COUNTY FILE NO. PPR-18-021

SHEET TITLE: PLANTING PLAN, DETAILS AND NOTES

LANDSCAPE DEVELOPMENT PLAN

ACADEMY VILLAGE FILING NO. 3

PLANTING PLAN

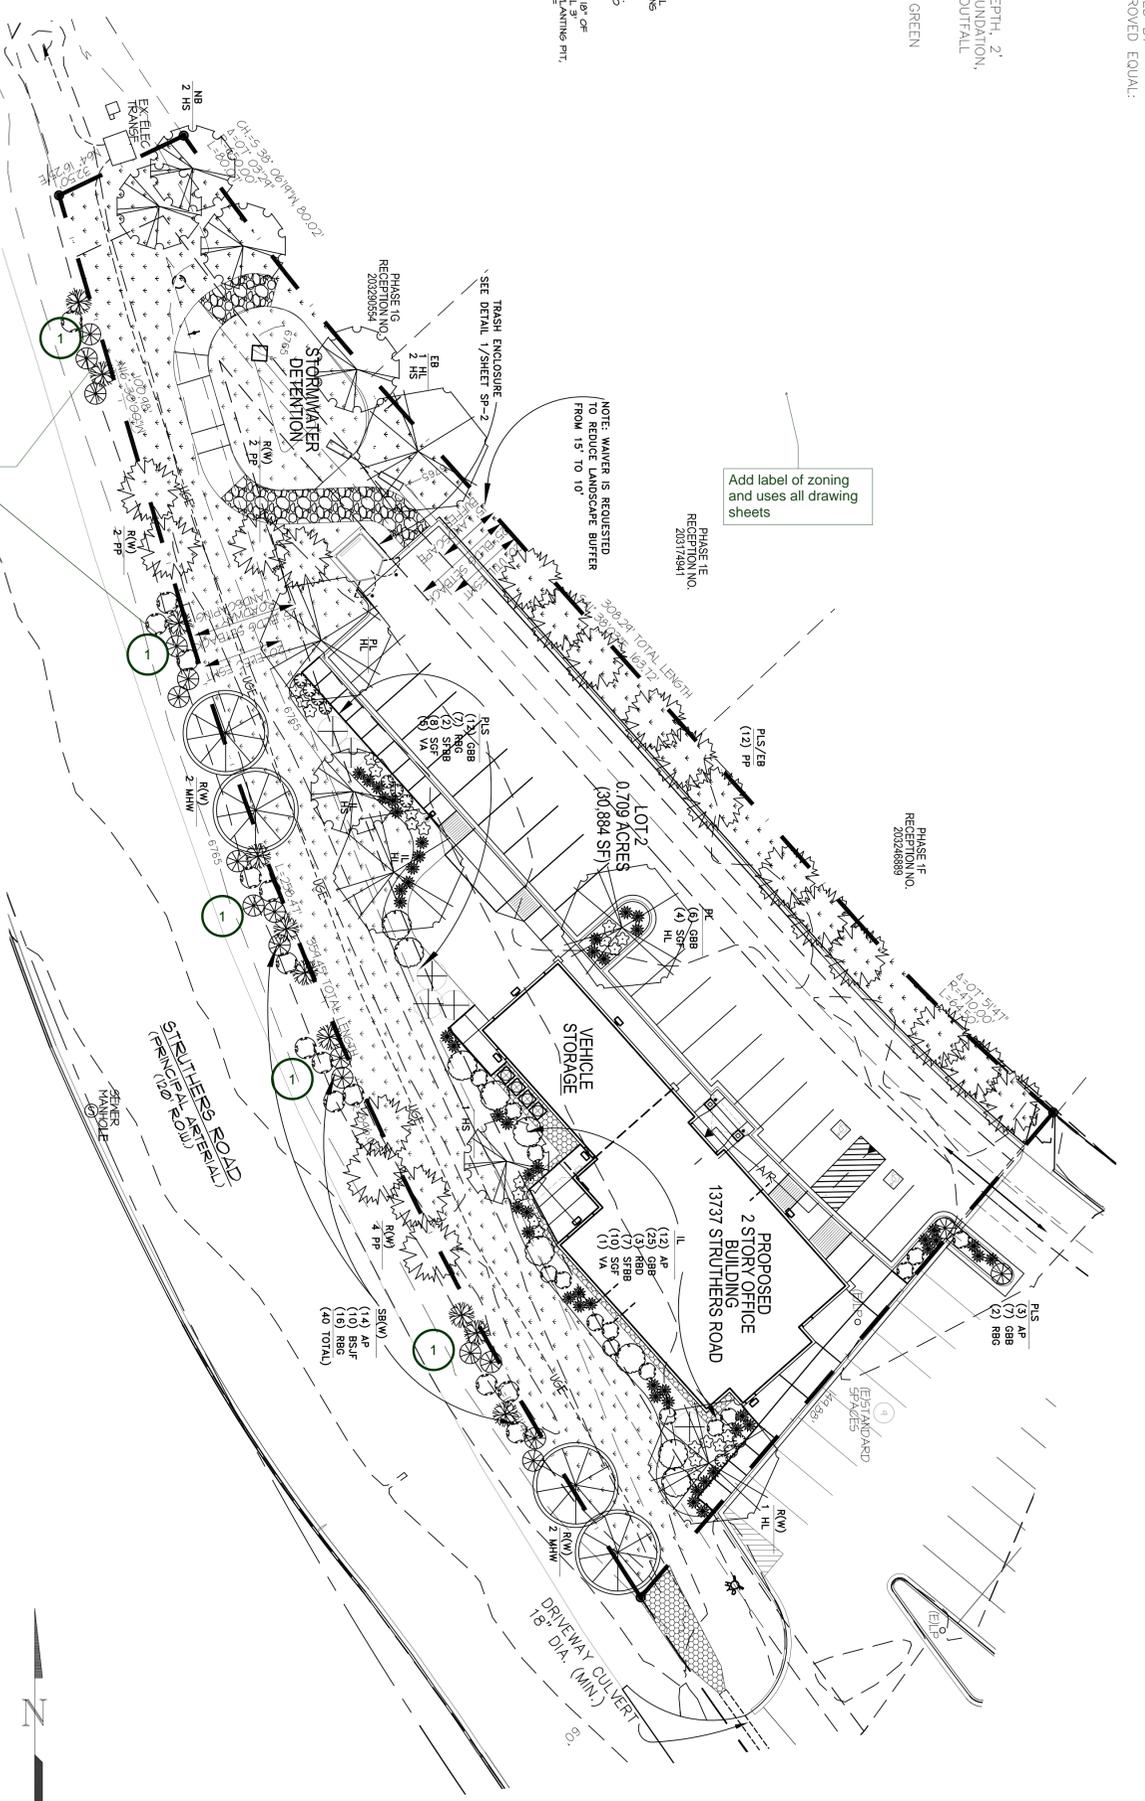
There was concerns with the buffer /compatibility at the hearing review staff does not support a reduction without justification. This is reviewed under todays standards.

10' buffer provided where 15' req. (label)

Move these to be on the site verses in the ROW.

So how many trees are actual provided? Are you substituting shrubs for NO 4 trees? so really theres 14 trees provided?

Add label of zoning and uses all drawing sheets

(Justify the north boundary exceeds buffer so asking for east buffer reduction)- All evergreen planted to justify depth reduction ??
